Subject: Issuance of Amendment No. 17 to Facility Operating License
NPF-9 - McGuire Nuclear Station, Unit 1

SAFETY EVALUATION BY THE
OFFICE OF NUCLEAR REACTOR REGULATION
RELATED TO AMENDMENT NO. 17
TO LICENSE NPF-9
DUKE POWER COMPANY

DILUTION OF BORON CONCENTRATION IN THE BORON INJECTION TANK

SAFETY EVALUATION REPORTCONTAINMENT UPPER COMPARTMENT TEMPERATUREMcGUIRE STATION UNIT 1BACKGROUND

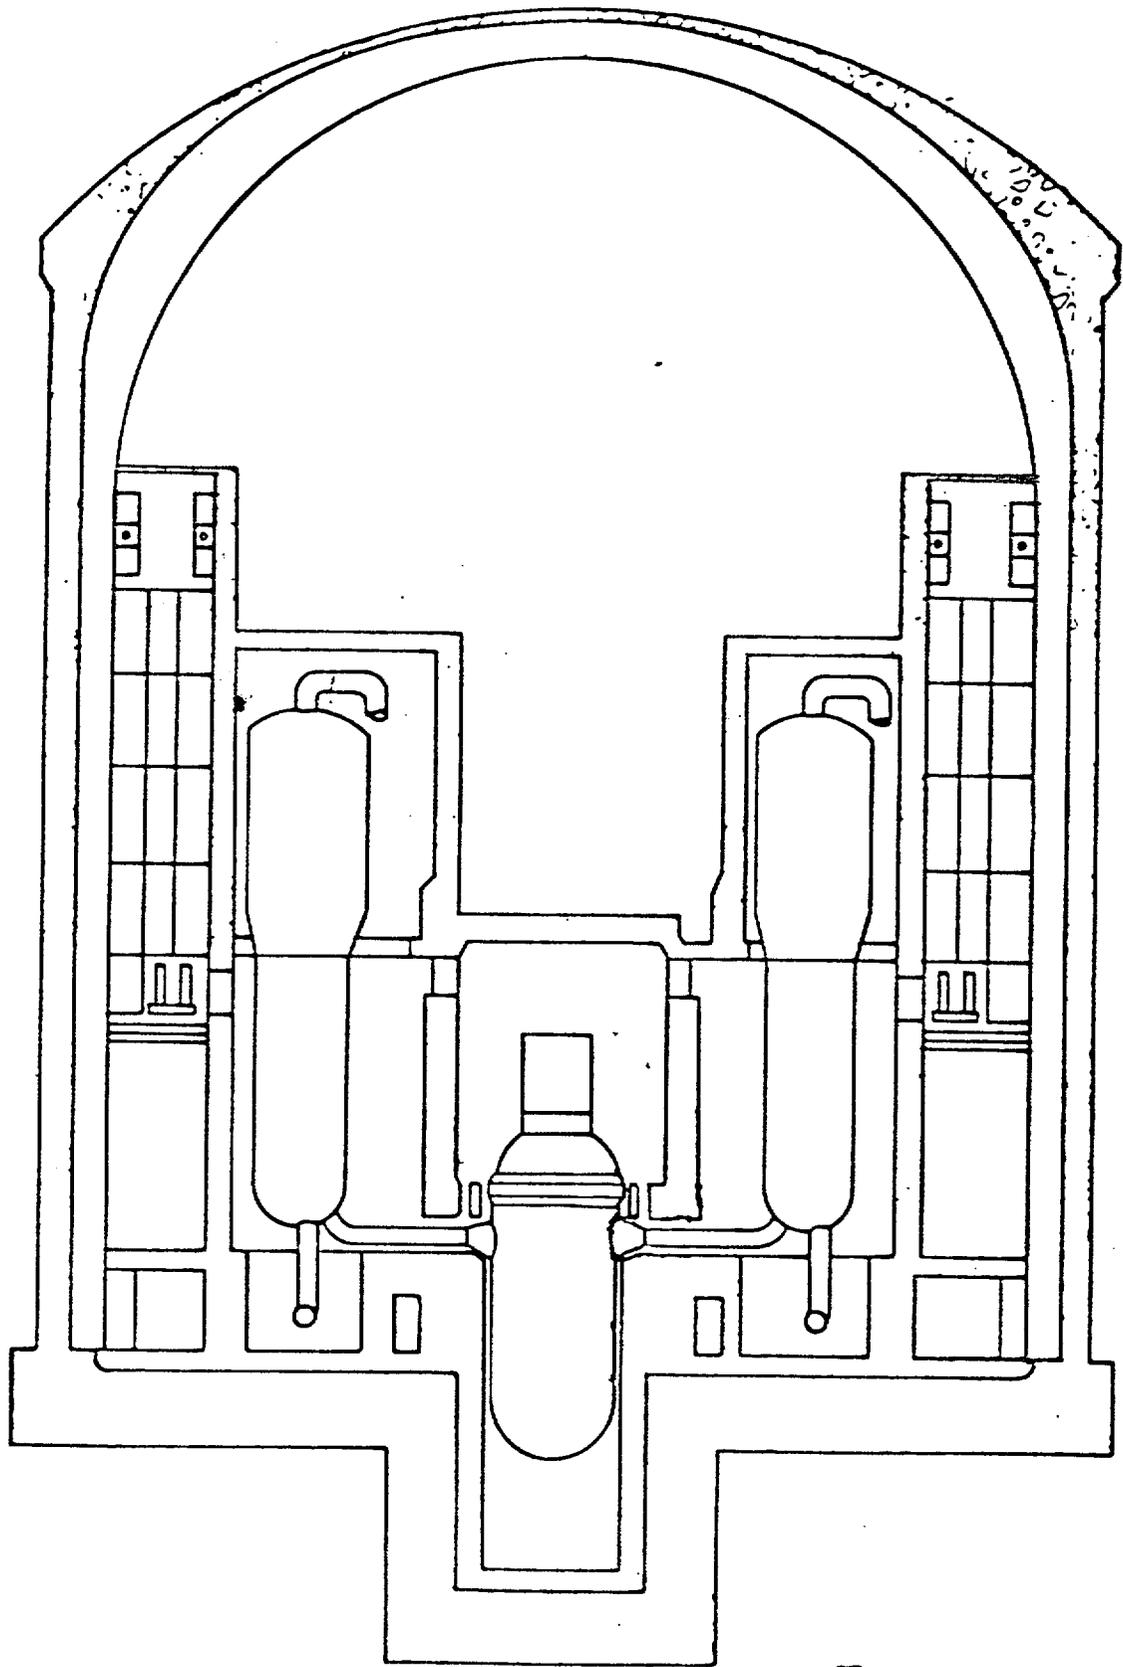
The McGuire Nuclear Station utilizes an ice condenser as a pressure mitigating system in containment. As shown on the attached figure the McGuire containment is physically divided into an upper and lower compartment. The barrier is designed to prevent steam from bypassing the ice condenser in the event of a postulated pipe rupture. Thus steam emanating from either a loss of coolant accident or a main steam line break inside containment will be forced to flow through the ice baskets which are located along the containment's perimeter. Since the steam resulting from a pipe break is largely condensed in the ice condenser, the containment internal design pressure is only 15 psig.

As stated previously the initial mass of air in containment can have a significant affect on the peak pressure transient calculation. This is particularly true for small containments incorporating low design pressures. By placing a technical specification limit on the minimum operating temperature, the initial mass of air present in containment is limited. If a large pipe break is postulated inside containment, the containment pressure is increased by both the partial pressure of steam and the partial pressure of air as it is heated and expands.

The upper and lower compartment temperature limits are not standard for all ice condensers and are calculated on a plant specific bases. Generally speaking, plants that have a small margin between the peak calculated and design pressure for containment must maintain a relatively high minimum operating temperature in order to reduce the partial pressure of air. This can be seen in the cases of McGuire and Sequoyah in the table below. Bounding calculations using the ideal gas law show that both the McGuire and Sequoyah peak calculated pressures inside containment would approach design conditions if the minimum operating temperatures were lowered by approximately 10°F. Conversely, plants with a relatively large margin between calculated and design pressures such as D.C. Cook are able to operate with lower initial containment temperatures.
